# TECHNICAL INFORMATION

| Bulletin # | Date       | Page |
|------------|------------|------|
| MAS001748  | 17/12/2018 | 1/4  |

**MODEL:** Maserati Levante equipped with small braking system (Opt 5LR)

**SUBJECT:** New front calipers holding brackets

The image below shows the differences between the caliper in old and new configuration.

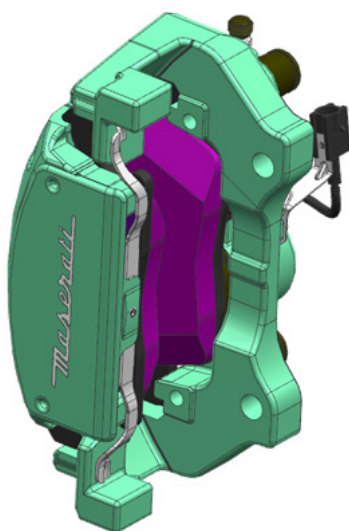
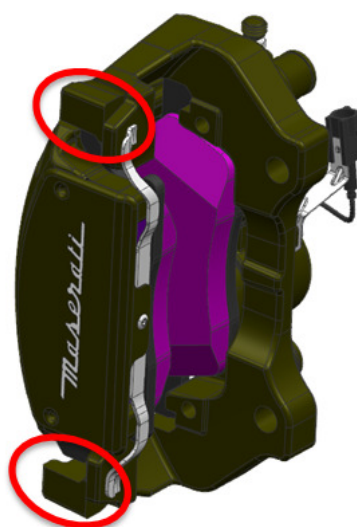
The Maserati Levante vehicles for SOP up to MY18 included, could present noisy occurrences from the small braking system when the braking phase is prolonged.

In case of customer complaints, the phenomenon can be avoided using the new front calipers holding brackets.

These new brackets modify the resonance frequency of the braking system, eliminating the annoying phenomenon.

Hereby the P/N of the brackets depending by the calipers colour:

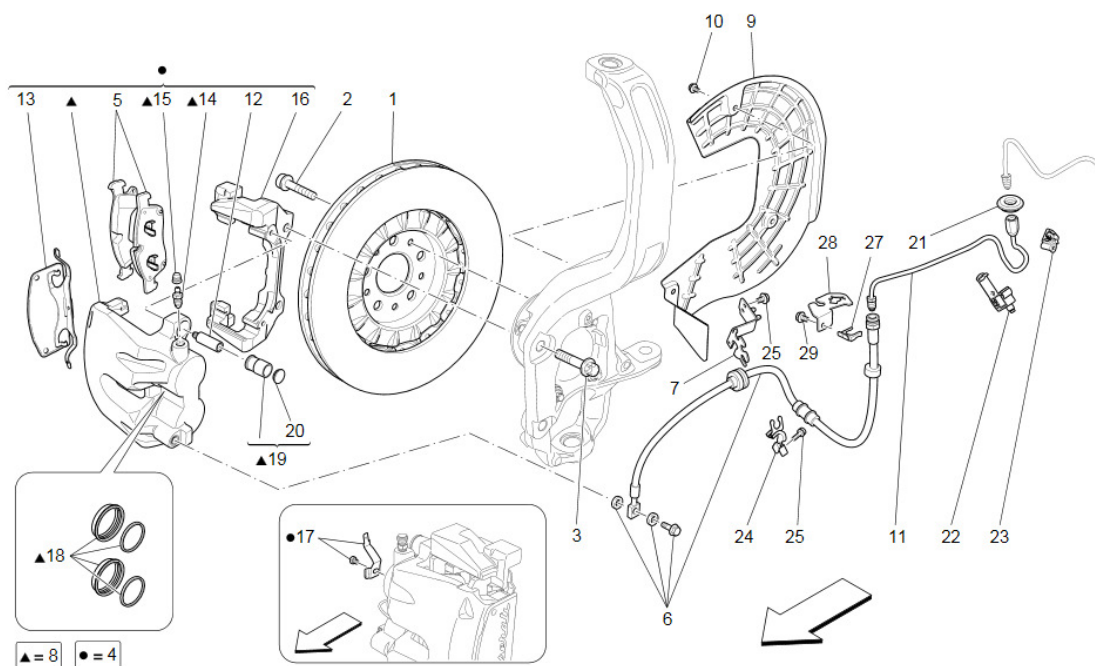
1. Follow the Procedure 4.10.005 – 15 of the Workshop Manual up to point 7 included and remove the caliper and the pads.
2. Remove the two screws (component 3 of the below image) that fix the old bracket (component 16 of the below image) to the hub-holder.

3. Replace the old bracket with the new one and fix it at the hub-holder using two brand new screws. Tight the screws at 185 Nm.
4. Refit the pads and the caliper following the removal procedure in reverse order. Tight the two screws (component 12 of the above image) that fix the caliper at the bracket at 55 Nm (+ 5Nm).
